**ALERT SERVICE BULLETIN**

**SUBJECT:** REVISION "B" TO ALERT SERVICE BULLETIN 407-99-33,  
V<sub>NE</sub> RESTORATION TO 140 KIAS, INTRODUCTION OF

407-99-33

**SUBJECT:** **V<sub>NE</sub> RESTORATION TO 140 KIAS, INTRODUCTION OF.**

**Figure 1. Installation of New Airspeed Limitation Decal and Removal of Airspeed Indicator Glass Markings (Sheet 1 of 2)**

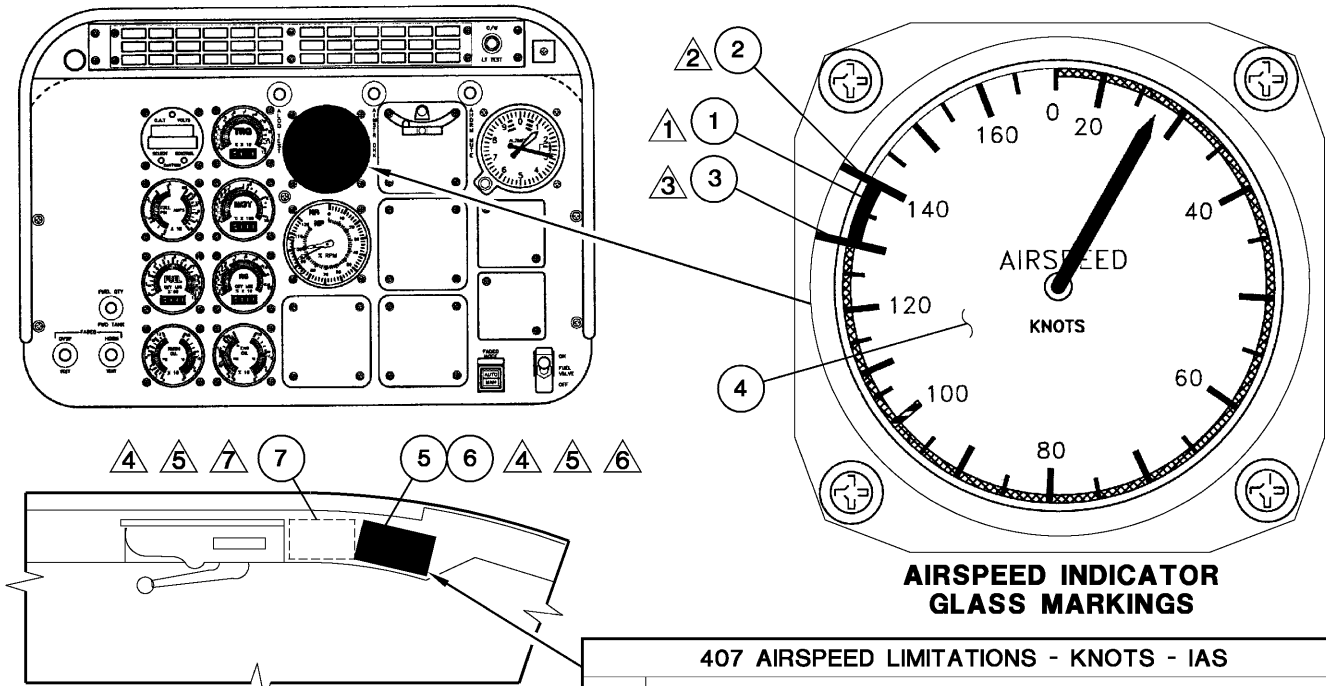
1. (Refer to Figure 1). If not completed in PART I, Step 1, then remove the temporary airspeed indicator glass markings.

- 1) Install the decal, Airspeed Limitations (6, Figure 1) as follows:

- (a) Remove the airspeed limitation decal (5) found on the overhead trim panel near the windshield.

- (b) Lift one corner of the decal with a sharp knife and remove it.
- (c) In the location of the decal you removed, install the new adhesive-backed decal.
- (d) Apply edge sealer (C-349) to the edges of the decal.

On the helicopters supplied with the dual control kit, 407-706-702-ALL, one more decal (5) is installed on the co-pilot side of the overhead trim panel. Replace this decal (5) with the new decal (6). (Refer to Step 1).

- 1) Install the decal, 407 (5250 LB) Airspeed Limitations (7, Figure 1) as follows:
  - (a) In a location adjacent to the decal, Airspeed Limitations (5 or 6, Figure 1) install the new adhesive-backed decal (7).
  - (b) Apply edge sealer (C-349) to the edges of the decal.

**Figure 2. New Directional Control Rigging Procedure (Sheet 1 of 2)**

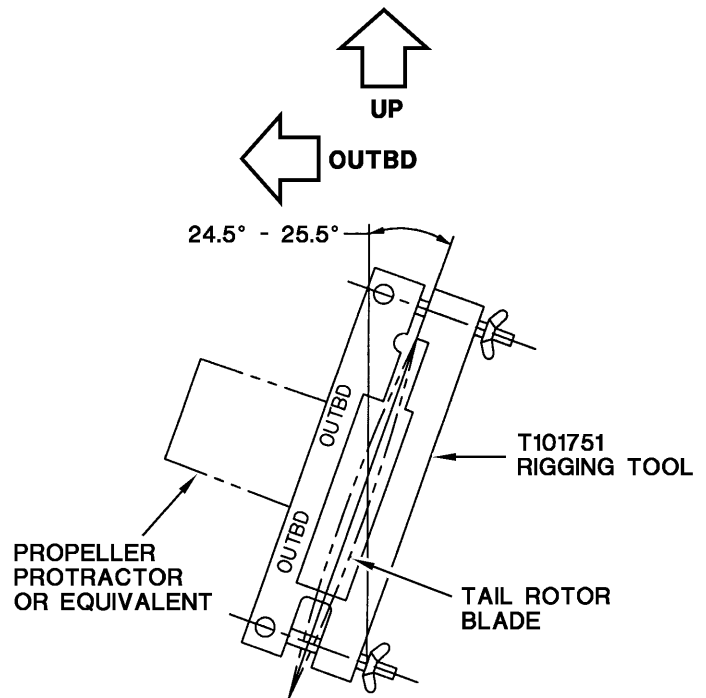
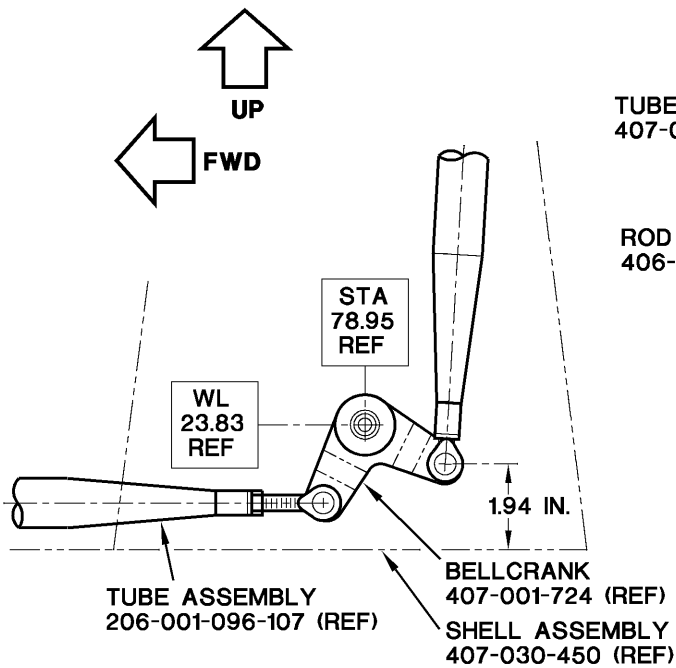
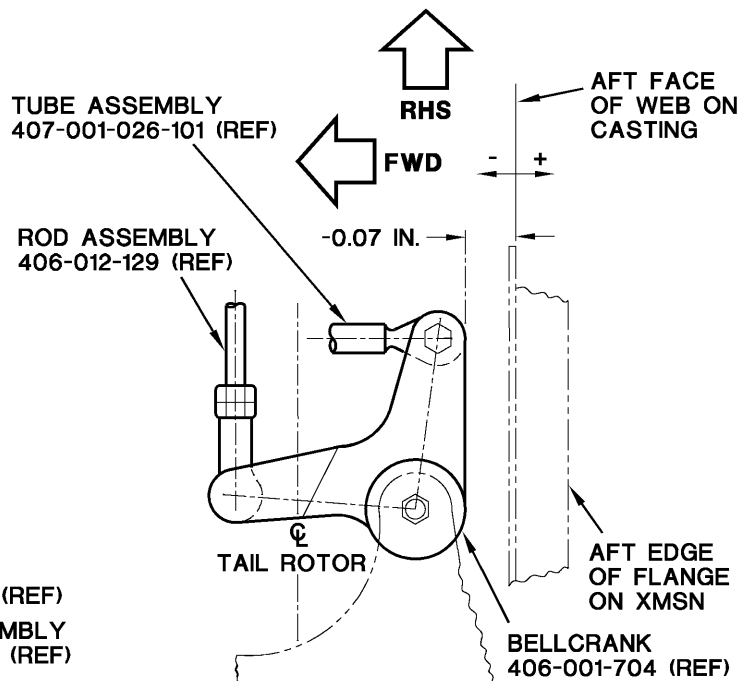
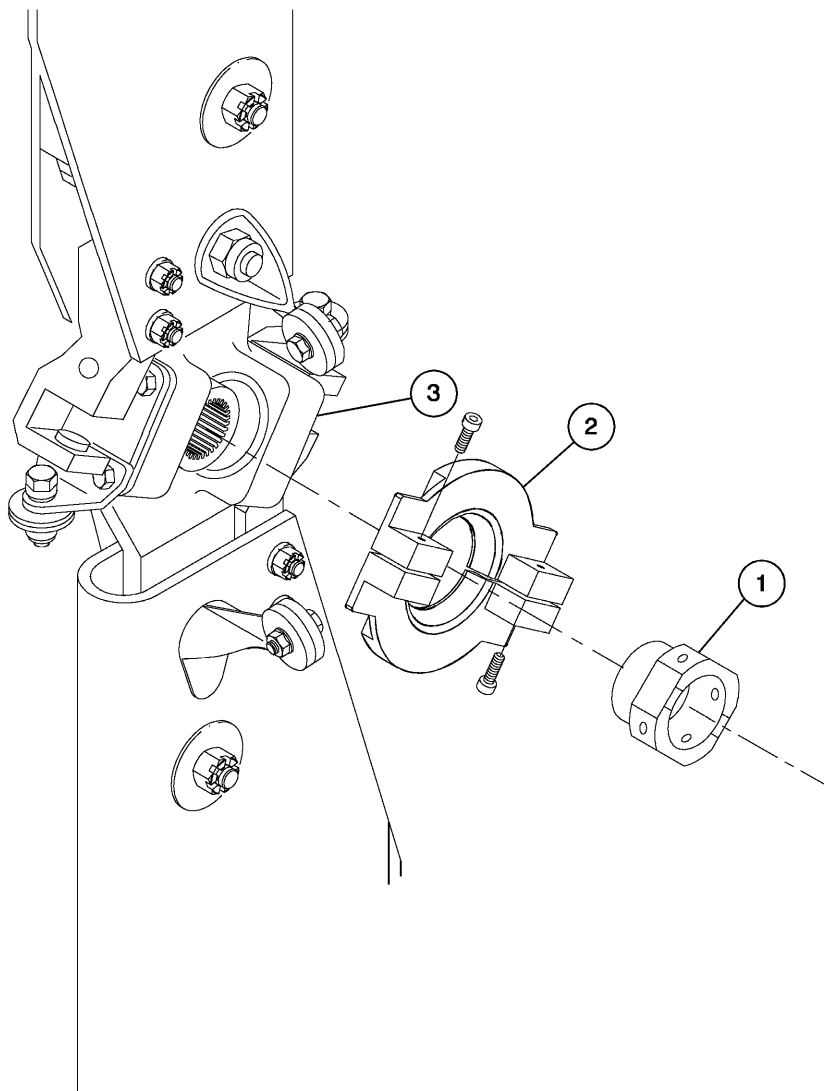
- b) Make sure that the directional pedal angle (BHT-407-MM-8, Paragraph 67-94, Step 2 and Figure 67-24, Detail A) is **now  $52^{\circ} \pm 0.5^{\circ}$**  with the pedal stop not engaged. The initial value was  **$46^{\circ}$** . If the dimension is **not  $52^{\circ} \pm 0.5$** , adjust the value.

- c) Make sure that the dimension between the floor and the bellcrank (BHT-407-MM-8, Paragraph 67-94, Step 5 and Figure 67-24, Detail B) is **now 1.94 inches (49.30 mm)** with the pedal stop not engaged. The initial value was **2.13 inches (54.10 mm)** If the dimension is **not 1.94 inches, (49.30 mm)** adjust the dimension.

- d) Make sure that the dimension between the bellcrank and the aft face of web on the casting (BHT-407-MM-8, Paragraph 67-94, Step 16 and Figure 67-24, Detail C) is **now – 0.07 inch (1.78 mm)** with the pedal stop not engaged. The initial was **– 0.35 inch. (8.90 mm)** If the dimension is **not – 0.07 inch (1.78 mm)**, adjust the dimension.

- e) Put the tail rotor blade in the horizontal position and hold within  $0.5^{\circ}$ . Install the workaid (Figure 2, Sheet 2) on the tail rotor assembly.
  - f) Make sure that the mean tail rotor blade angle (BHT-407-MM-8, Paragraph 67-94, Step 15. Figure 67-25, View B-B) is **now  $24.5^{\circ}$  to  $25.5^{\circ}$**  with the pedal stop not engaged. The initial values were  **$18.7^{\circ}$  to  $19.7^{\circ}$** . If the mean angle is **not  $24.5^{\circ}$  to  $25.5^{\circ}$**  adjust it (refer to BHT-407-MM-8, Paragraph 67-94, Step 18).
2. Make an entry in the helicopter Historical Record (HR) to show that this bulletin is completed.
  3. Make an entry in the record of the Alert Service Bulletin in the Maintenance Manual.
